# McLaren 750S – HVAC Controls Enhancement

<b>Bulletin type:</b>	Service Campaign
<b>Reference number:</b>	N/A
<b>Campaign reference:</b>	SCB 28 M 001
<b>Attention:</b>	Retailer Aftersales Managers, Retailer Service Managers, Retailer Service Advisors, Retailer Technicians, Retailer Parts Managers
<b>Affected vehicles:</b>	McLaren 750S
<b>Situation:</b>	ADI casing rework for 'ghost touch' on Federal vehicles
<b>Procedure:</b>	Action affected vehicles on first opportunity (immediately if already on site or during next Retailer visit if not already on site). Please refer to the information outlined in this document to complete the required work
<b>Date:</b>	29 November 2024

Image 1: Overview of the ADI bracket assembly

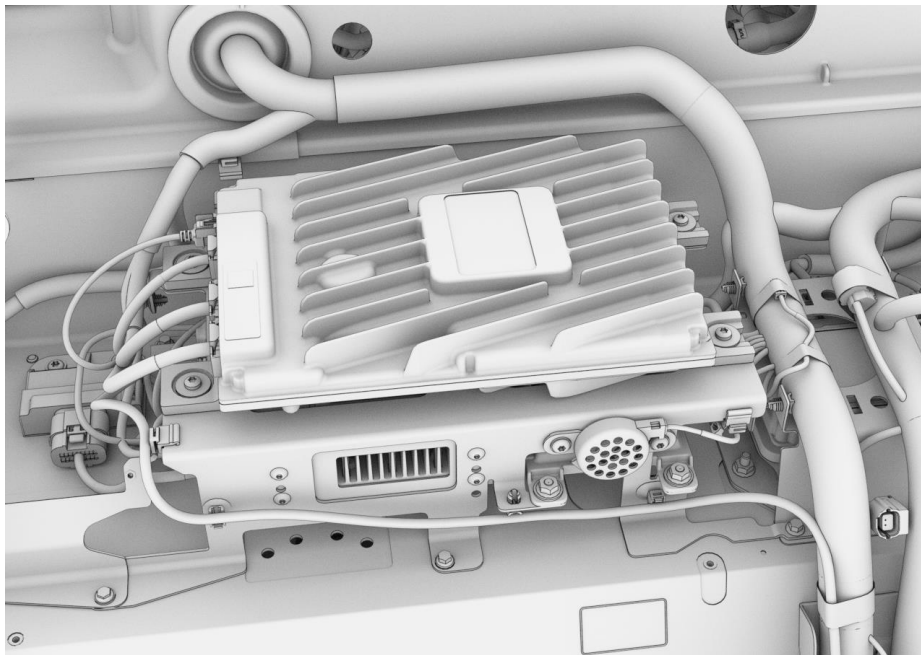
Through continuous product quality monitoring, McLaren Automotive has identified that on McLaren 750S vehicles in the Federal market, there is a possibility for the HVAC controls to become unresponsive. This document outlines the rework details required on the Amplifier/Infotainment Control Unit bracket assembly to bring the vehicle up to current manufacturing standard.
